PLANT NAME: Oconee 1, 2, & 3

ENCLOSURES:  
Proposed Amdt to GL/Change to Tech Specs:  
consisting of revised & addl pgs and info  
concerning pressurization heatup & cooldown  
limitations and to the reactor vessel material  
surveillance program.....(40 cys encl rec'd)

Re: Oconee Nuclear Station  
Docket Nos. 50-269, -270, -287

3.1.2 Pressurization, Heatup, and Cooldown Limitations

Figure 3.1.2-1A

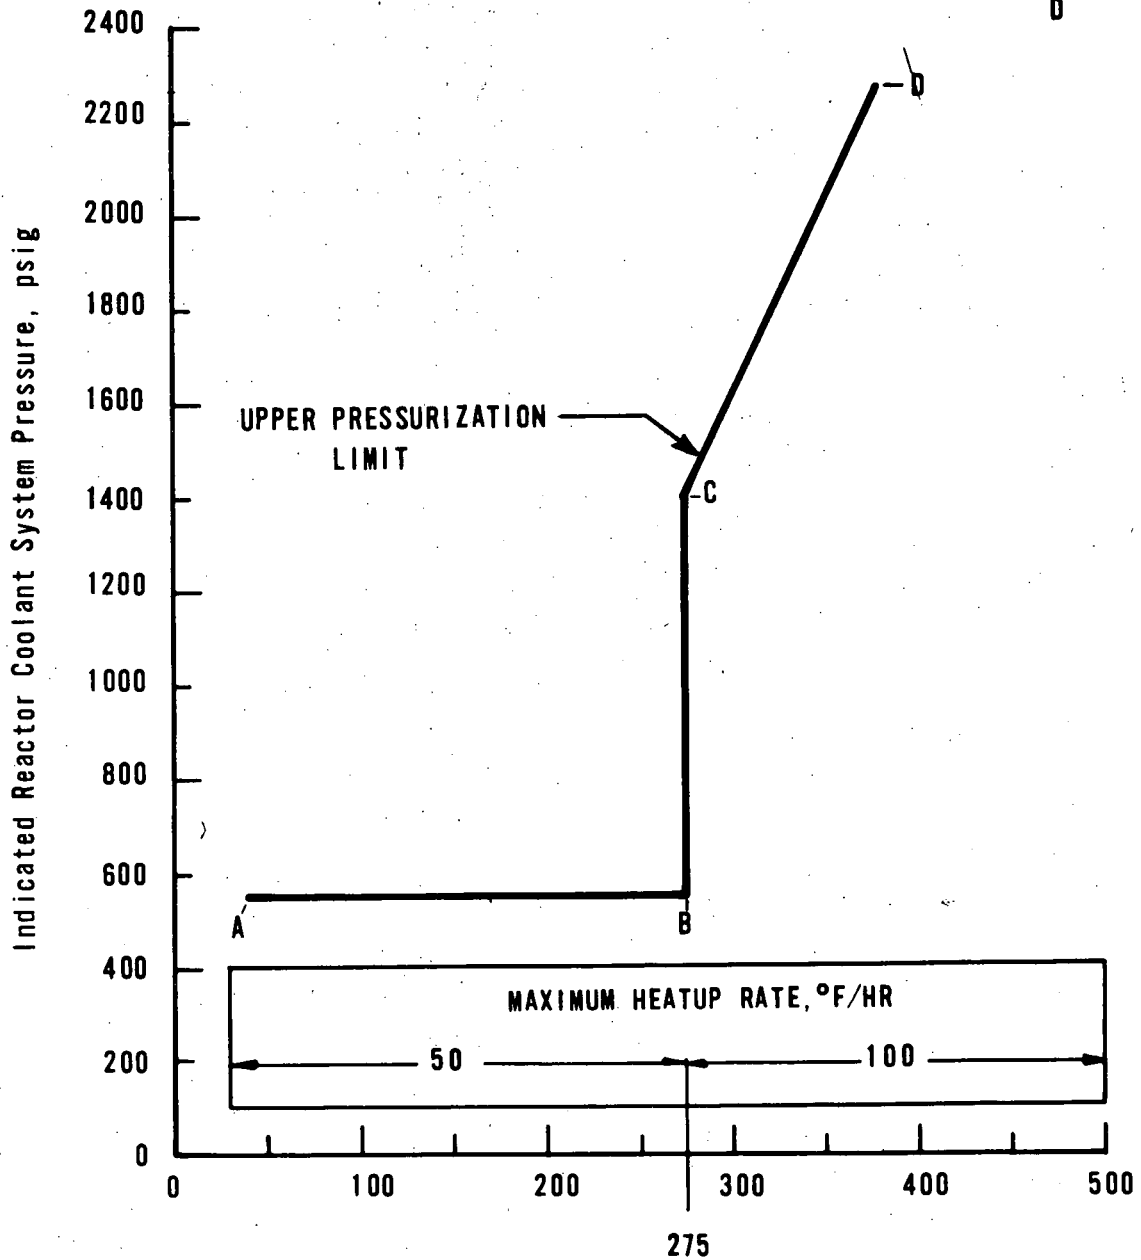
Heatup rates and allowable combinations of pressure and temperatures shall be limited in accordance with Figure 3.1.2-1A Unit 1  
3.1.2-1B Units 2&3.

Figures 3.1.2-1A, 3.1.2-2A, and 3.1.2-3 present the pressure-temperature limit curves for normal heatup, normal cooldown and hydrostatic test respectively. The limit curves are applicable up to the fifth effective full power year of operation. These curves are adjusted by 25 psi and 10°F for possible errors in the pressure and temperature sensing instruments. The pressure limit is also adjusted for the pressure differential between the point of system pressure measurement and the limiting component for all operating reactor coolant pump combinations.

The pressure-temperature limit lines shown on Figure 3.1.2-1A for reactor criticality and on Figure 3.1.2-3 for hydrostatic testing have been provided to assure compliance with the minimum temperature requirements of Appendix G to 10CFR50 for reactor criticality and for inservice hydrostatic testing.

POINT	TEMP.	PRESS.
A	40	550
B	275	550
C	275	1400
D	380	2275

Figure 3.1.2-2A

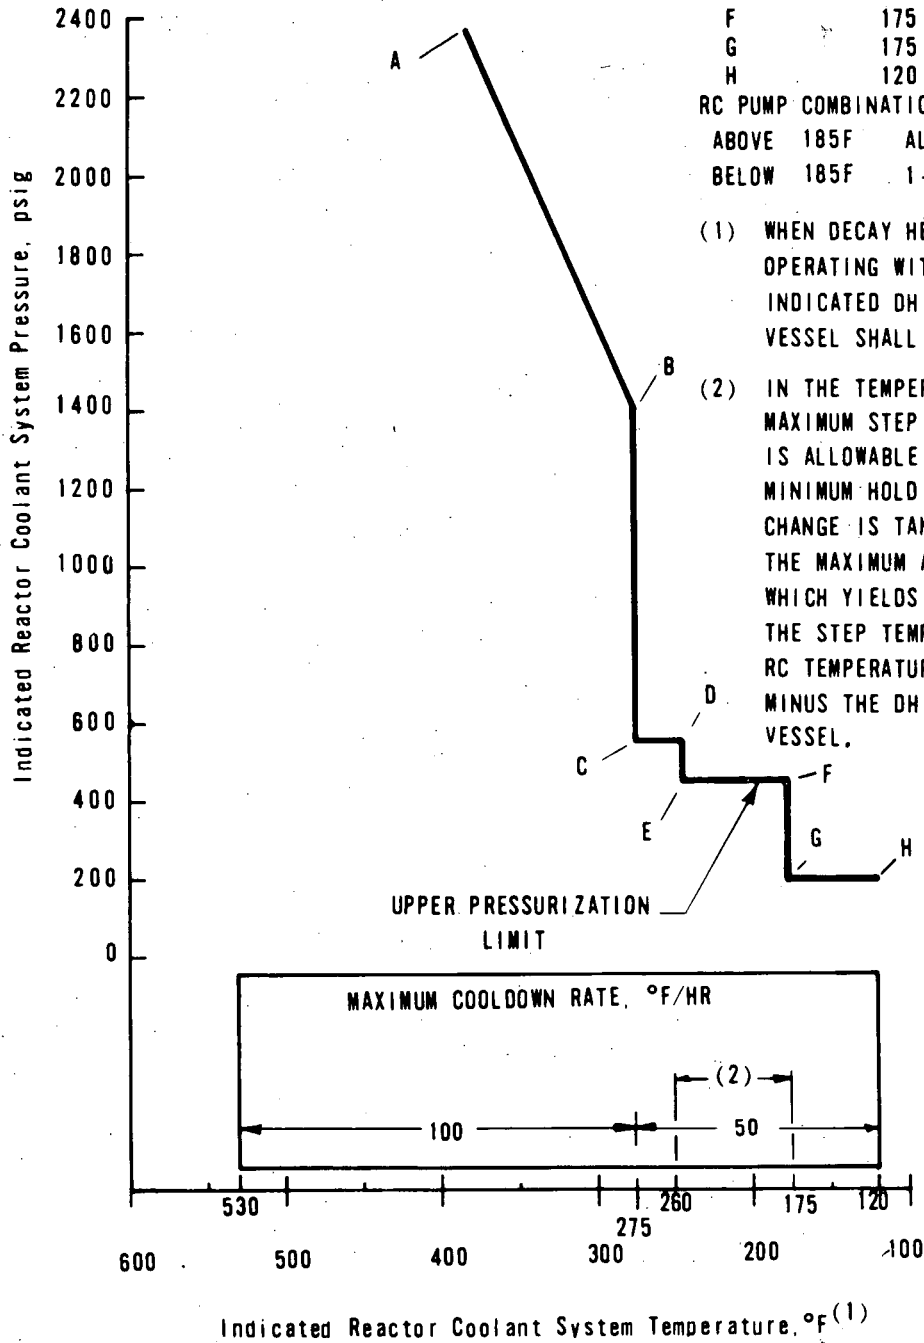
Cooldown rates and allowable combinations of pressure and temperature shall be limited in accordance with Figure 3.1.2-2A Unit 1  
3.1.2-2B Units 2&3.

POINT	TEMP	PRESS
A	380	2275
B	275	1400
C	275	550
D	250	550
E	250	450
F	175	450
G	175	200
H	120	200

Figure 3.1.2-3

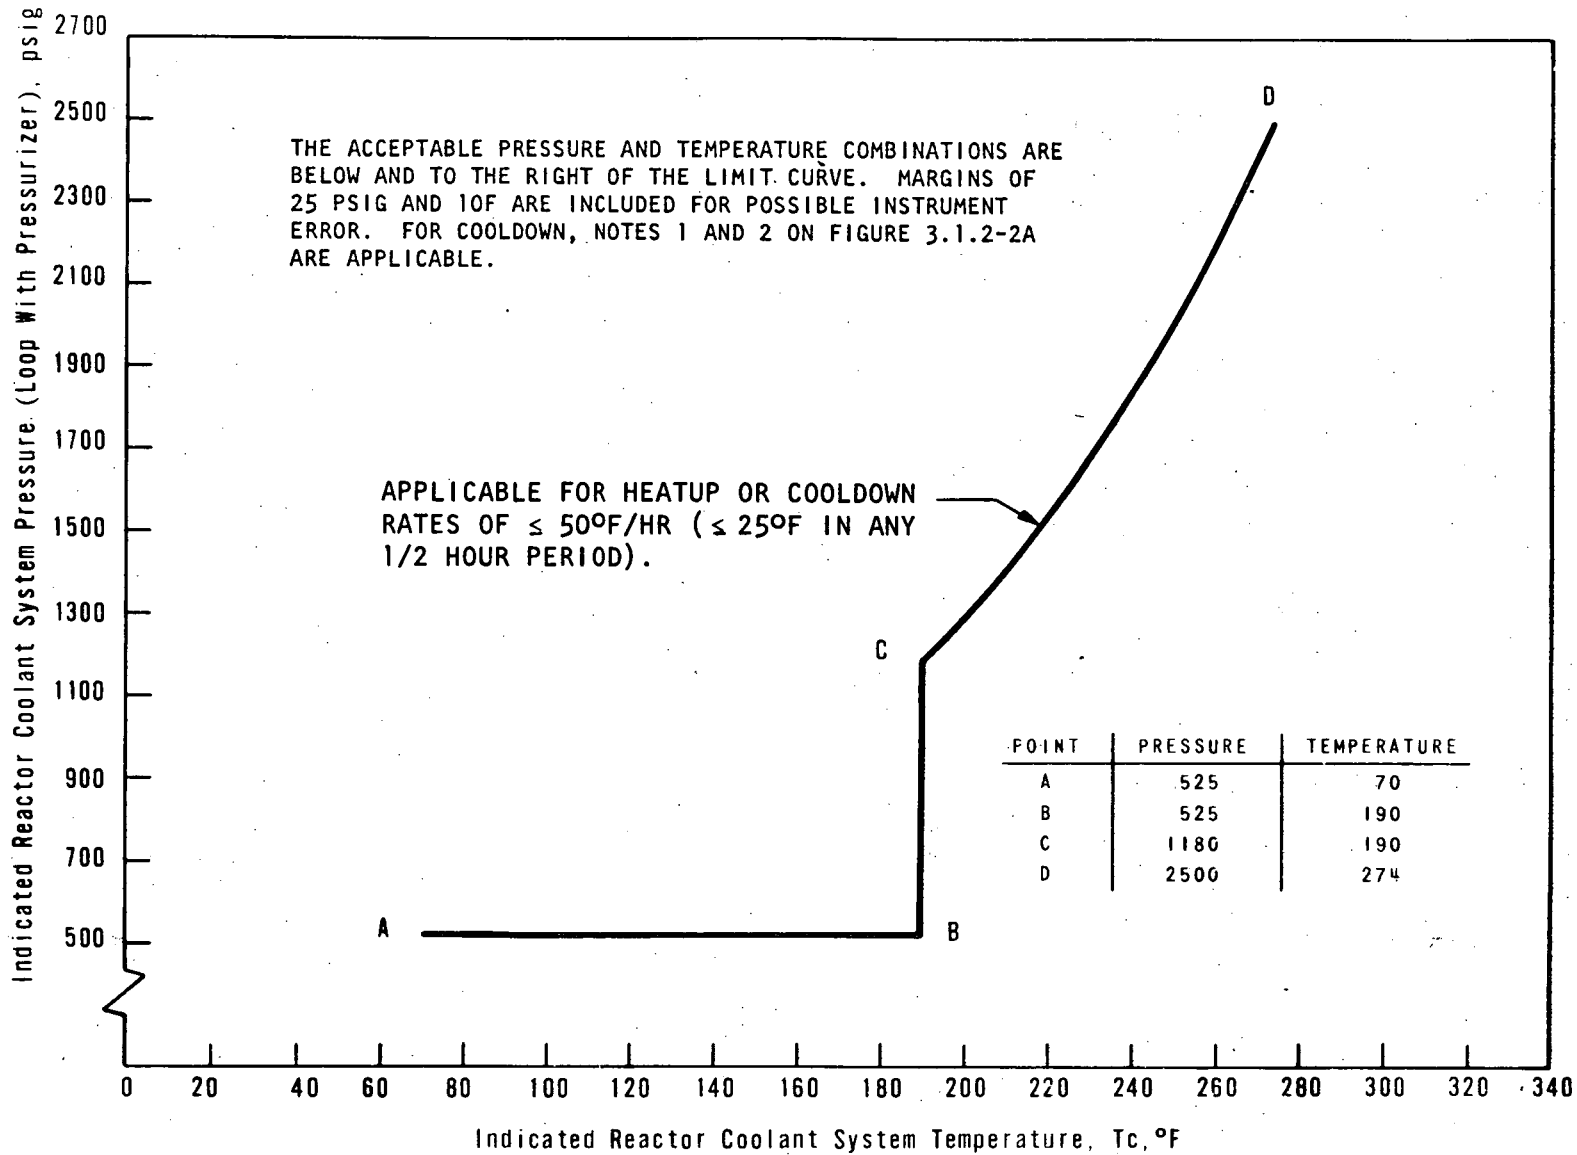
For thermal steady state system hydro test the system may be pressurized to the limits set forth in Specification 2.2 when there are fuel assemblies in the core under the provisions of 3.1.2.1 and to ASME Code Section III limits when no fuel assemblies are present provided the reactor coolant system is to the right of and below the limit line in Figure 3.1.2-3.

REACTOR COOLANT SYSTEM HEATUP AND COOLDOWN LIMITATIONS FOR INSERVICE HYDROSTATIC TESTS (NO FUEL ASSEMBLIES IN THE CORE), APPLICABLE FOR FIRST 5 EFPY
